工程變更客戶通知單

Engineering Change Customer Notification

ECR/ECN 單號： ECR/ECN Number:	EO000168
日期： Date:	2024/04/08
變更者/郵箱： Author/Mail	Hebe Tran
客戶端工程變更需求確認：(signature) EC request confirmation by customer	請於 10 工作日內簽回，若超過 10 日未簽回將視為同意此變更 Please sign back within 10 working days, if you do not sign back within 10 working days, you will be deemed to agree to this change.
客戶端工程變更完成確認：(signature) EC completion confirmation by customer	請於 10 工作日內簽回，若超過 10 日未簽回將視為已確認 Please sign back within 10 working days, if you do not sign back within 10 working days, it will be deemed as confirmed.

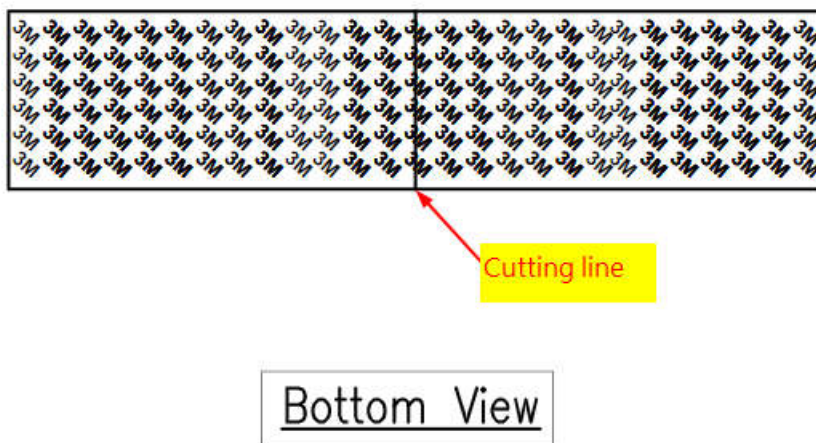
變更說明 Description of Change	To change the cutting line position from middle into side.	
變更影響 Impact of change	☒ 外觀 Appearance ☐ 功能 Function ☐ 規格 Specification ☐ 品質 Quality ☐ 可靠度 Reliability ☐ 法規 Regulations ☐ 包裝 Package: ☐ 其他 Others:	
	上述影響描述: Describe if above applies: Yes	change the cutting line position from middle into side.
預估轉換日期 Forecast Estimated Transition Date	Last buy (old product)	running change
	New buy (new product)	running change
